5.4 Components and Subsystem Design

The information in this section of the reference ABWR DCD, including all subsections, tables and figures, is incorporated by reference with the following departures and supplements.

Figure 5.4-1 Reactor Internal Pump Cross Section

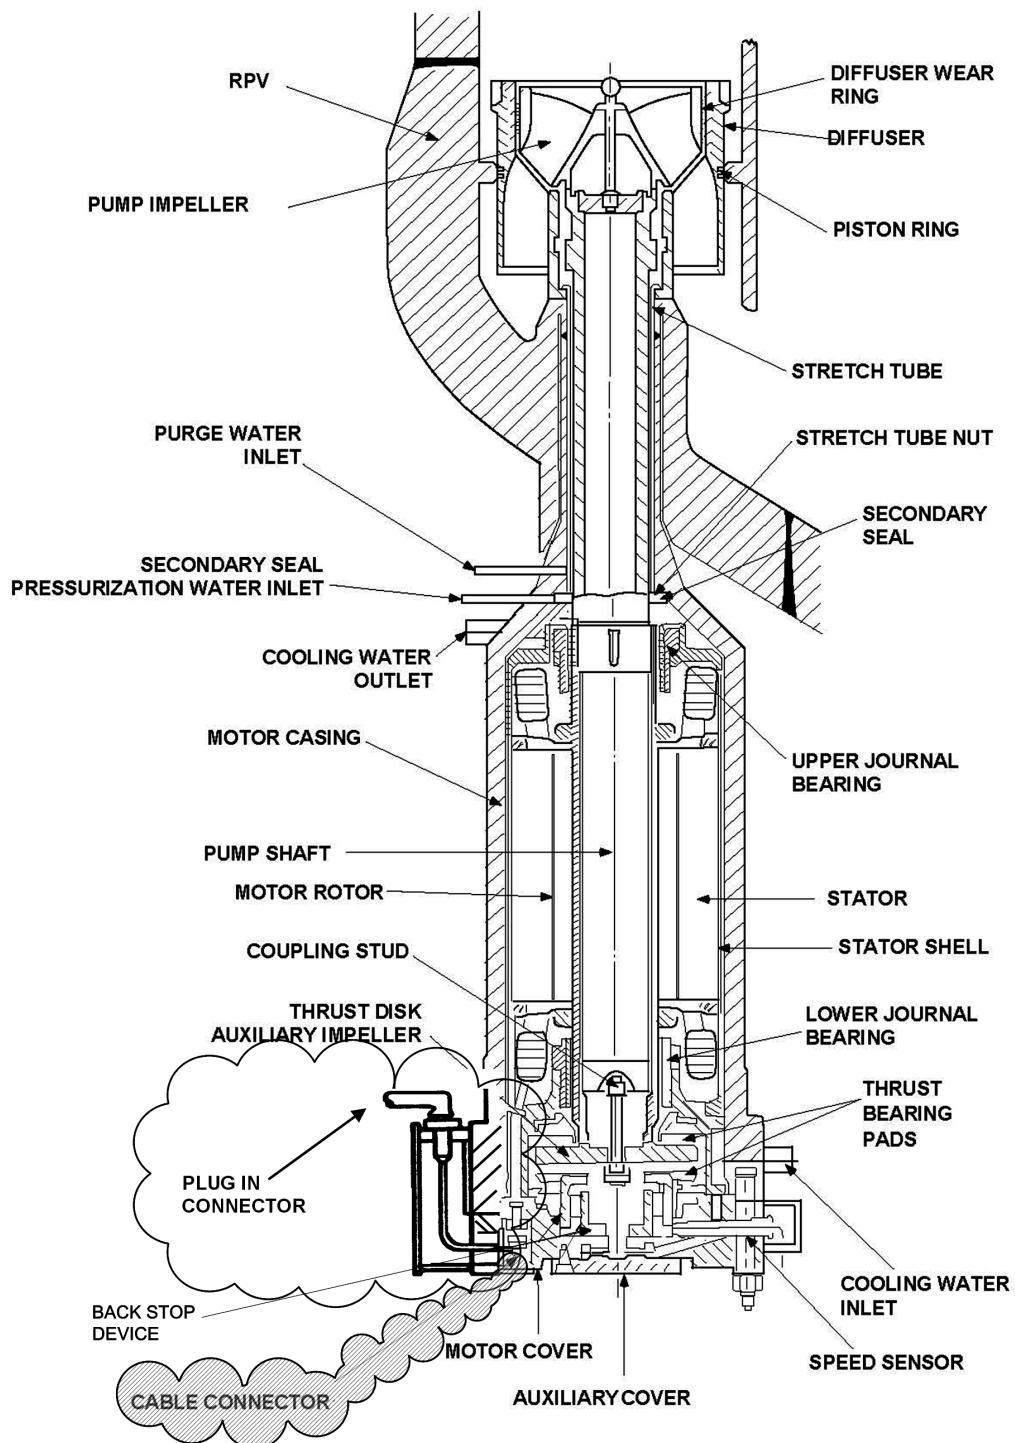
STD DEP 5.4-2 (Figure 5.4-1)
